# ● RIVER BEND STATION ENVIRONMENTAL REPORT

● OPERATING  
LICENSE  
STAGE

SUPPLEMENT 4

SUPPLEMENT 4 INSERTION INSTRUCTIONS RIVER BEND STATION  
ENVIRONMENTAL REPORT - OPERATING LICENSE STAGE

FIGURE 2.9-1

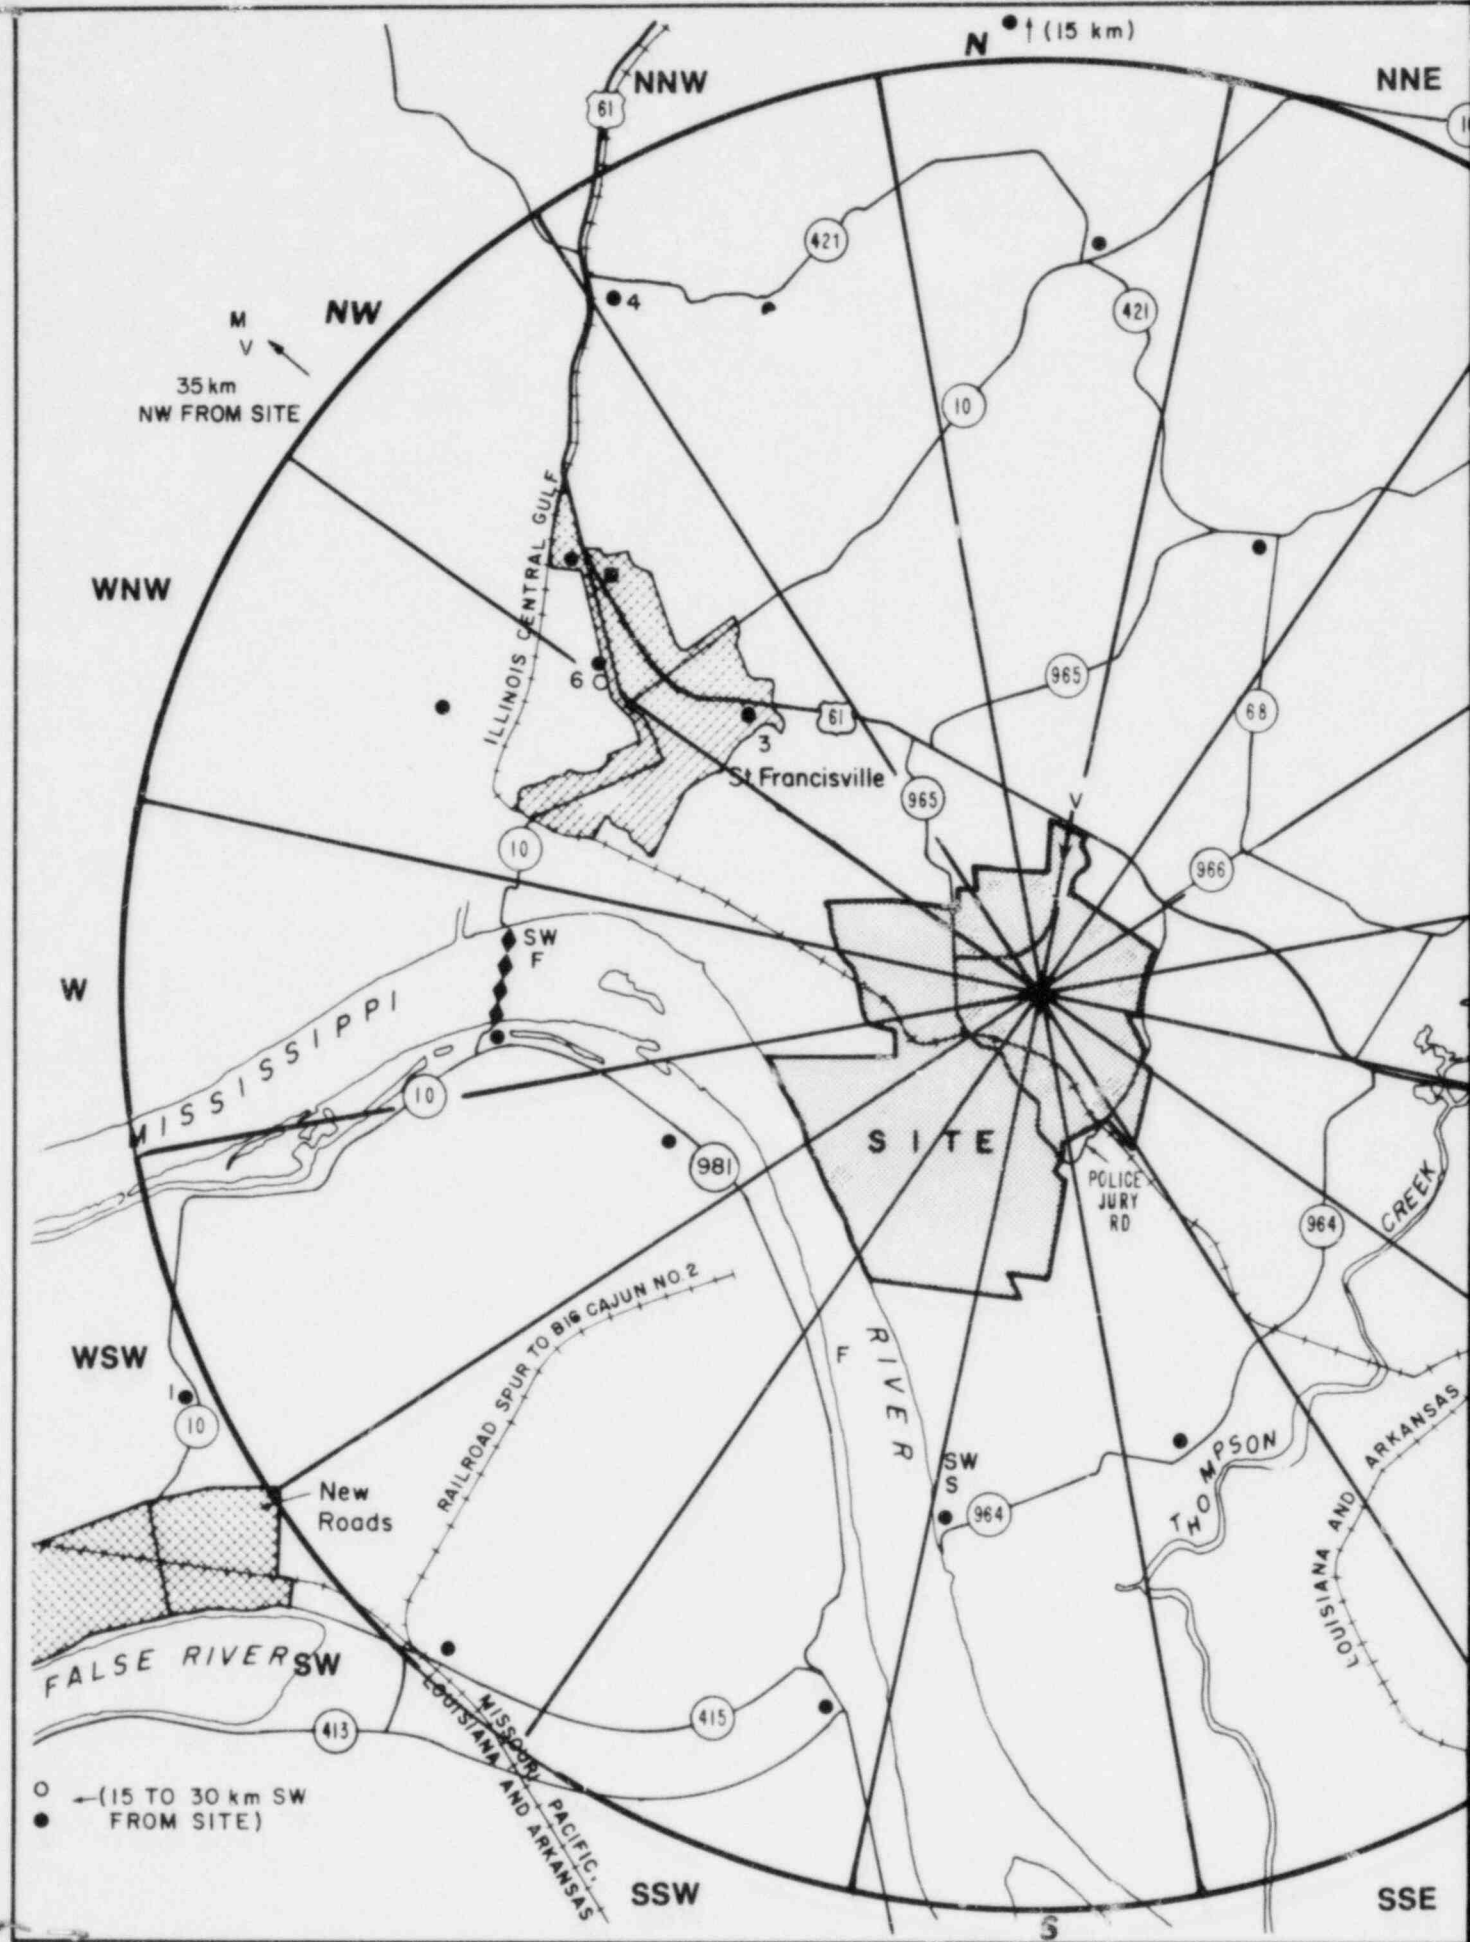
Provide a brief listing or discussion of noise-sensitive land uses within three miles of the River Bend Station (i.e., residences, schools, hospitals, churches, cemeteries). Indicate their locations with respect to the station and with respect to the ambient noise survey sampling locations.

There are a total of ten (10) noise-sensitive land uses within three (3) miles of the River Bend site. Figure 2.9-1 has been modified to define and indicate the locations of noise-sensitive land uses and their proximity with respect to the ambient noise measurement locations.
